**TOWN OF HARVARD
PLANNING BOARD AGENDA
MONDAY, JANUARY 8, 2024 @ 7:00PM**

**RE: 184 Ayer Road
Stormwater Site Plan Review
Harvard, MA**

Reference: Stormwater Site Plan Review
184 Ayer Road
Harvard, Massachusetts
B+T Project No. 3241.05

JOB NO. 6632-C
 DRAWING NO. 6632-C-LAND
 SHEET NO. **C4.0**

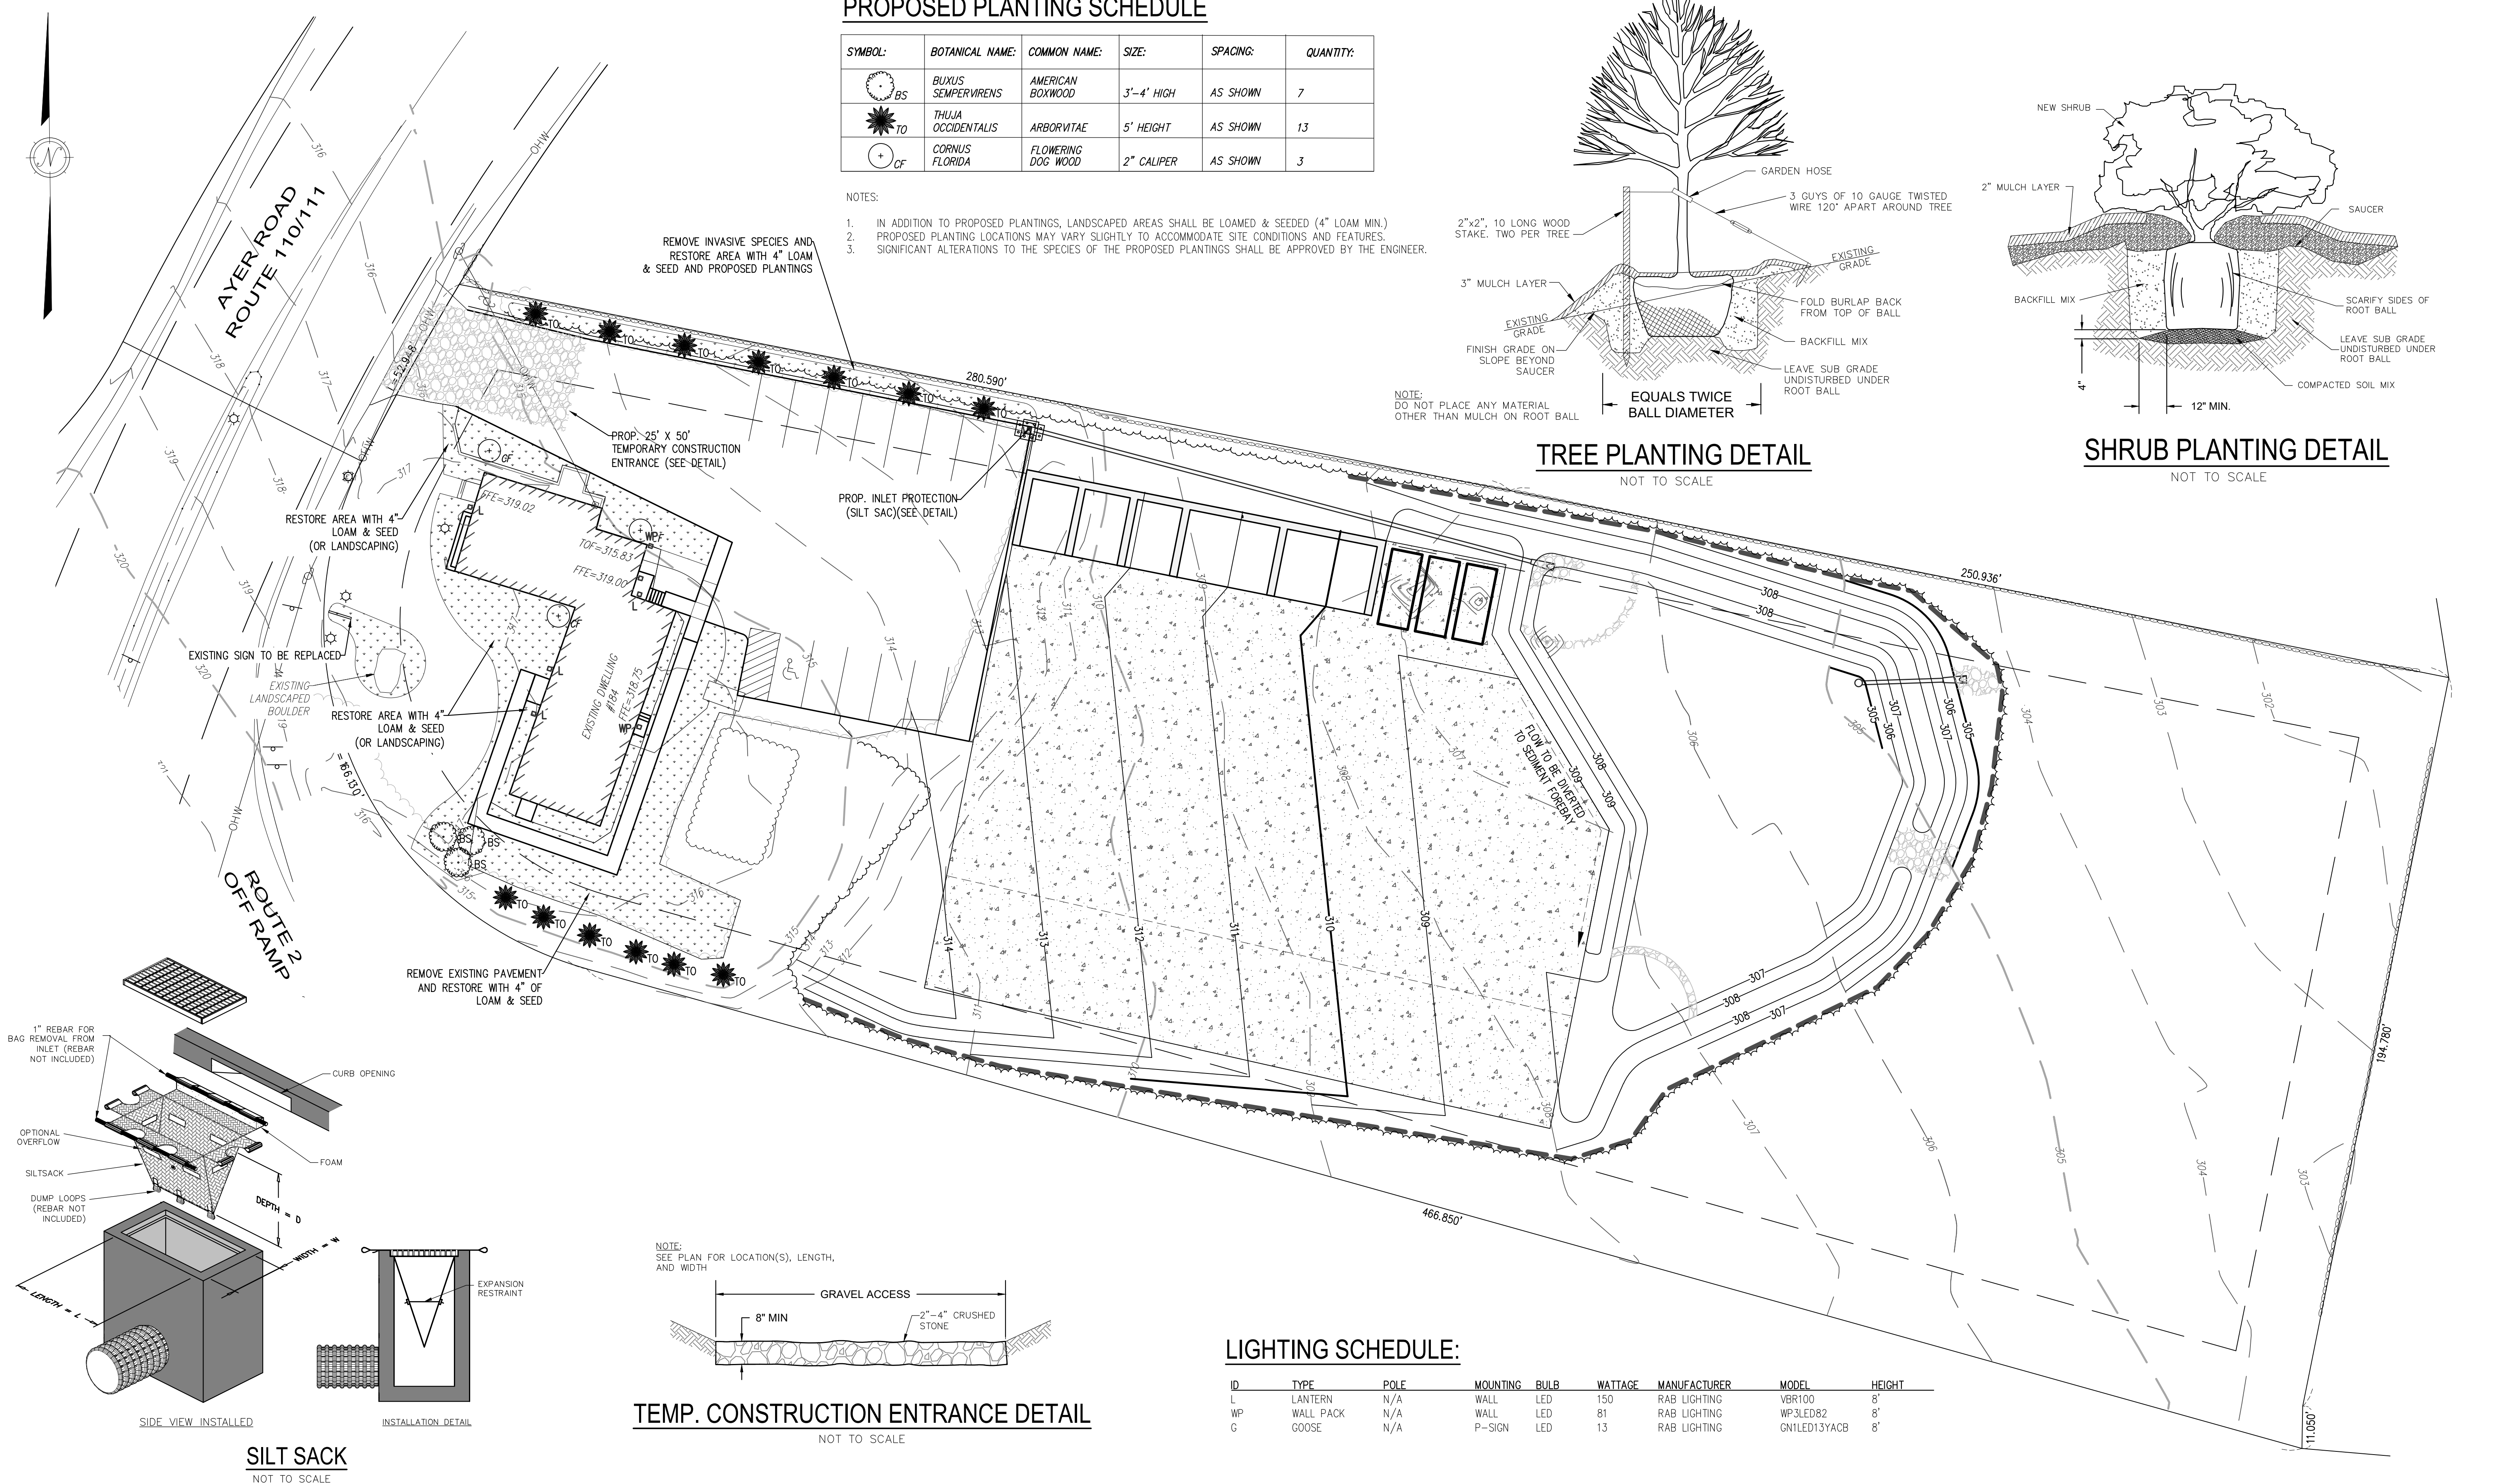
3. *Standard 8 of the Handbook requires a construction period pollution plan. Disrupting more than 1 acre, the Project will also need to file an EPA NPDES Construction General Permit with a Stormwater Water Pollution Prevention Plan (SWPPP). The Applicant had not provided construction period controls; however, intends to use the SWPPP to satisfy this requirement. The Applicant has not provided a SWPPP but intends to do so prior to construction. As a potential condition of approval, we recommend that the Applicant submit a fully compliant SWPPP prior to construction for Board review. In the meantime, we request that the Applicant update the site plan submission to include details and provisions for catch basin silt sack protections and a stabilized construction exit.*

D&R – Plan Sheet C4.0 has been revised to include the above-mentioned soil erosion & sedimentation control provisions. The applicant does not object to a condition requiring the submittal of the SWPPP once it is prepared.
